Access Compliance Report

Public Rights-of-Way

(Curb Ramps)

Intersection ID: 42506	Main Street: CHASEWATER_DR	Cross Street: DARBY_CHASE_DR	Location: SE
ADA ID: 3190FF877AD6	Ramp Type: Perp	Initial Pass/Fail: Fail	Overall Compliance: No
Severity Score: 10			
Codes/Mitigation Info/Possible Solution		Field Measurements/Component Compliance

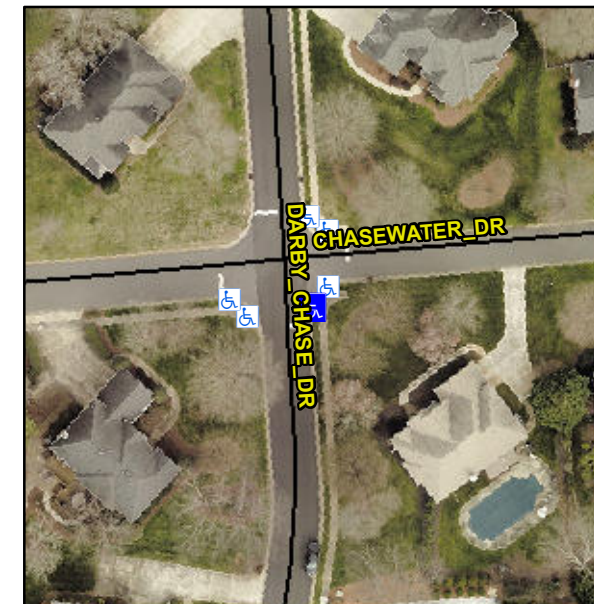
Not Found, R304.5.1, R304.5.3

Compliance	Description	Data	Compliance	Description	Data
N/A	Ramp Length (in)	42.0	Yes	Ramp Slope (%)	6.2
No	Ramp Width (in)	38.5	No	Ramp XSlope (%)	3.5
N/A	Flare Type LT	N/A	N/A	Flare Type RT	N/A
N/A	Flare Slope LT (%)	N/A	N/A	Flare Slope RT (%)	N/A
N/A	Flare Traversable LT?	N/A	N/A	Flare Traversable RT?	N/A
N/A	Landing Length (in)	N/A	N/A	DWS Provided?	N/A
N/A	Landing Width (in)	N/A	N/A	DWS Contrast?	N/A
N/A	Landing Slope (%)	N/A	N/A	DWS Length (in)	N/A
N/A	Landing X Slope (%)	N/A	N/A	DWS Full Width?	N/A
N/A	Landing Curb? (Y/N)	N/A	N/A	DWS Offset (in)	N/A
N/A	Shared Landing?	N/A			
N/A	Gutter Ponding?	N/A	N/A	Gutter Slope (%)	N/A
N/A	Gutter Lip Ht (in)	N/A	N/A	Gutter X Slope (%)	N/A
N/A	Painted X Walk1?	No	N/A	Painted X Walk2?	N/A
	X Walk 1 Direction	To W		X Walk 2 Direction	N/A
N/A	X Walk 1 Width (in)	N/A	N/A	X Walk 2 Width (in)	N/A
	X Walk 1 Slope (%)	2.8		X Walk 2 Slope (%)	N/A
	X Walk 1 X Slope (%)	3.1		X Walk 2 X Slope (%)	N/A

Remove & Replace Entire Ramp.
